RE: Albuquerque School of Excellence – Remodel
13201 Lomas Blvd NE, Albuquerque, NM 87112

Final Certificate of Occupancy: Traffic Circulation Layout

ALBUQUERQUE SCHOOL OF EXCELLENCE

TRAFFIC CIRCULATION
LAYOUT PLAN

B1 TRAFFIC CIRCULATION LAYOUT PLAN
1" = 40'-0"

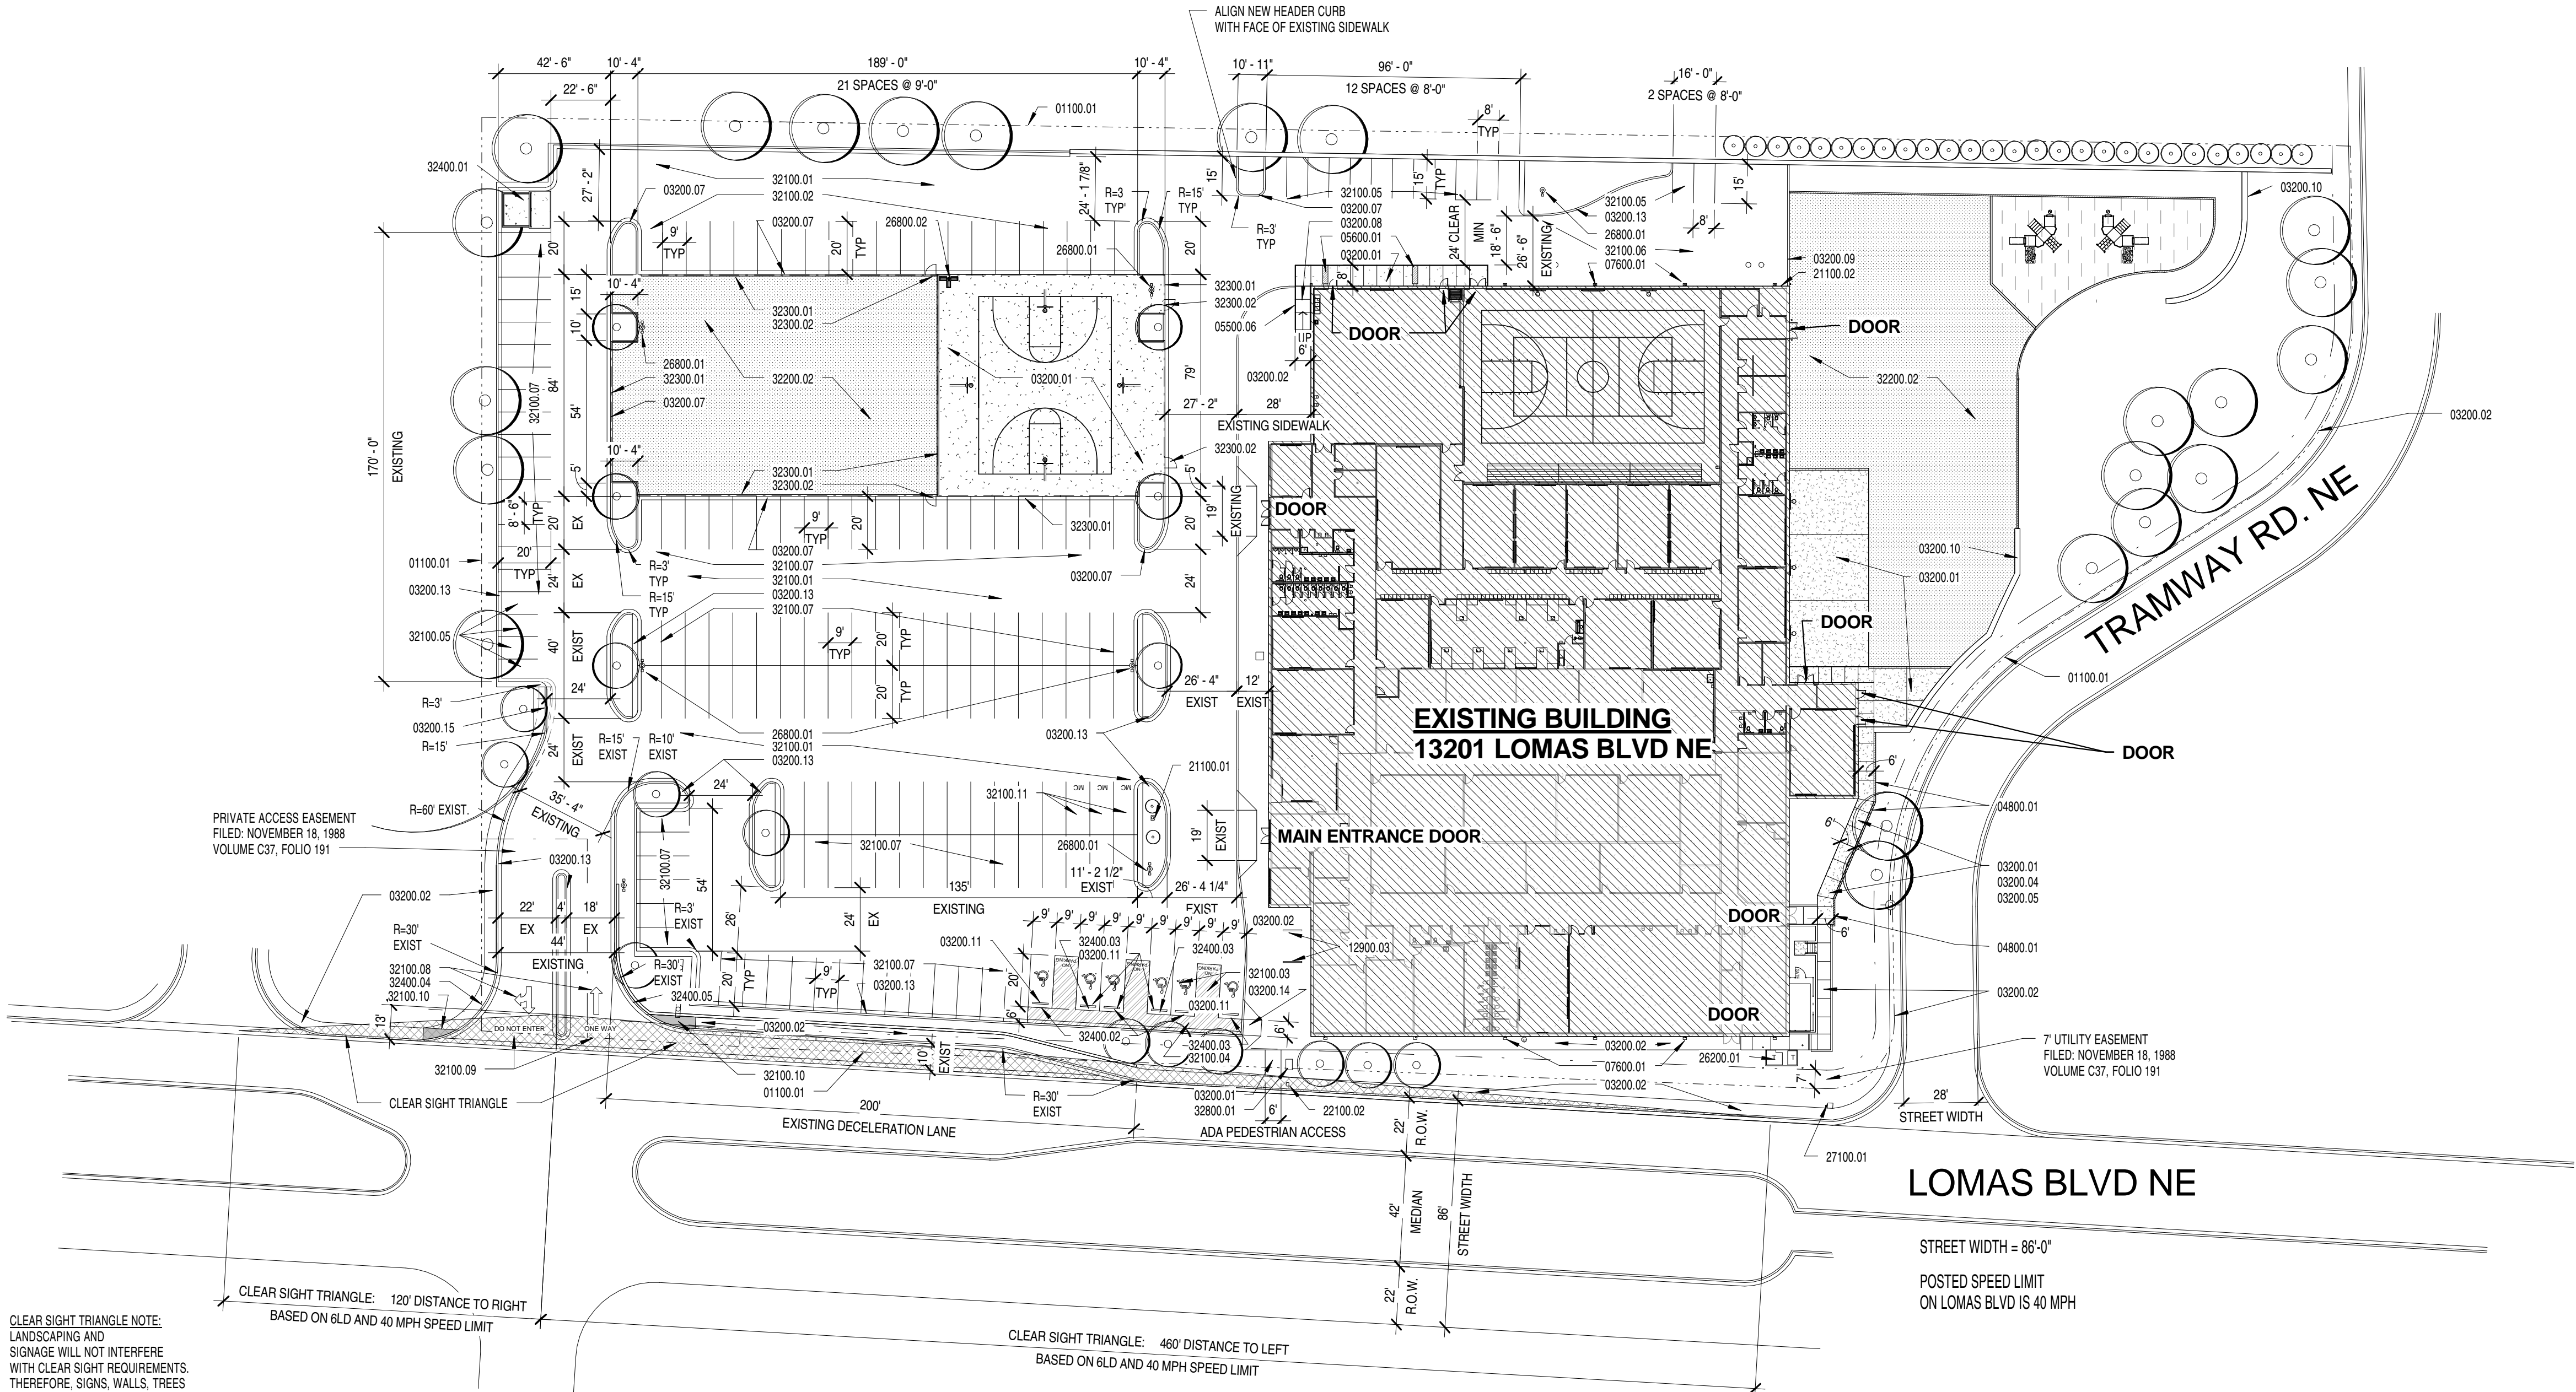
The Owner of the project referenced above has decided to not perform some of the Site Improvements on the project as described and illustrated in the Drawings and TCL. The playground/recreation areas on the west side of the building (within the parking lot) and on the east side of the building will not be constructed at this time. The asphalt areas will remain as is.

These items were redlined in the City and General Contractor's Permit Sets.

Therefore, as suggested by Monica Ortiz, we would like to withdraw the TCL from the Permit Set and not have that work as a condition of approval for a Final Certificate of Occupancy.
